EQUIPMENT UPDATE

Log Number: EU-09-367

Part: 1/3 HP OVERLOAD RELAY

Models Affected: CMA-44 & CMA-66 CONVEYOR

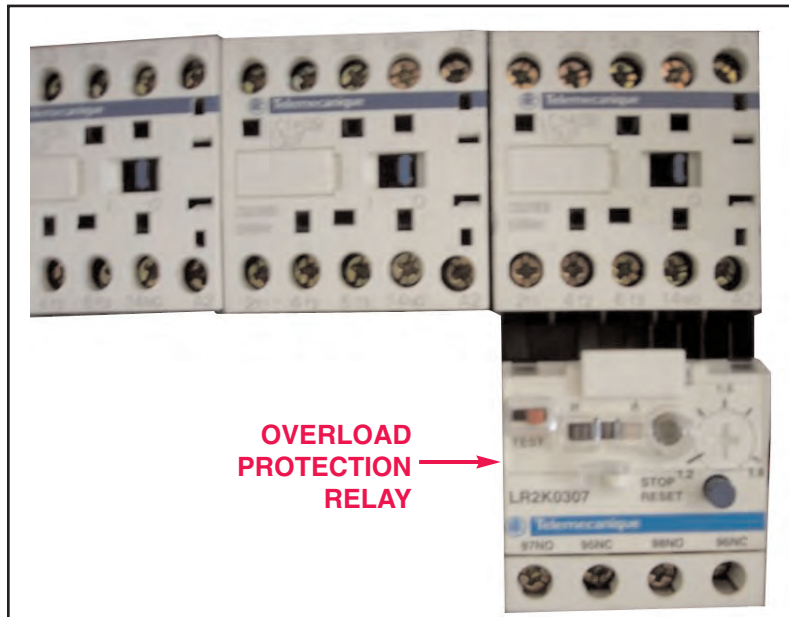
CONVEYOR MOTOR OVERLOAD RELAY:

Underwriters Laboratory has requested that CMA supply overload protection on the CMA-44 and CMA-66 conveyor motor. As of September 1, 2005 all conveyor motor contactors have overload protection relays. If overload conditions were to occur, the relay will trip and can be field re-set.
